Date: August 16, 2007
Order No.: S-B-68.00/54a
Supersedes: S-B-68.00/54
Group: 68

SUBJECT: *Model 164 / 203 / 209 / 211 / 216 / 219 / 221 / 251*
Model Year - All

One-Time Use of Expansion Rivet with Sealing Function - Protecting Systems from Water

Figure 3

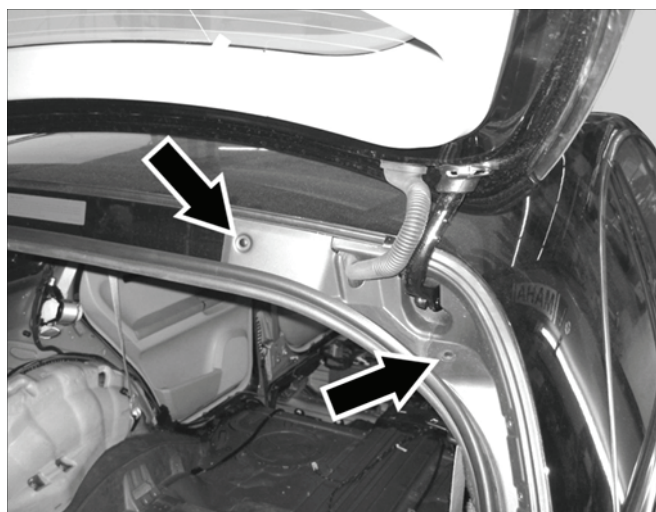
3. Anytime it is necessary to remove one of these rivets, throw it out and replace it with a new one (Figure 3).

4. Critical installation locations are the D-pillar cover in the rear-end door on the Model 251 (Figure 3).

Figure 4

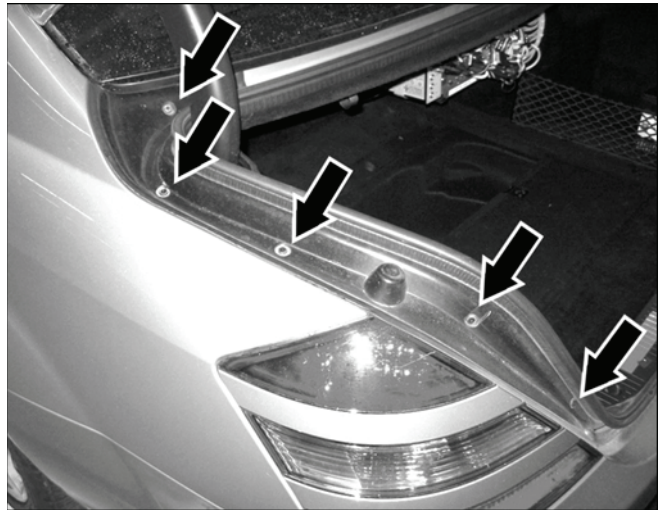
5. Another critical installation location is the body shell cover of the trunk lid as shown on the Model 221 (Figure 4).
6. Other locations include, among others: right rear fender on Model 211; paneling and lining of luggage compartment cover on Model 209 and 211; head protection curtain on Model 219; the A-, B- and C-Pillar paneling on Model X164; and the heater case on Model 221.
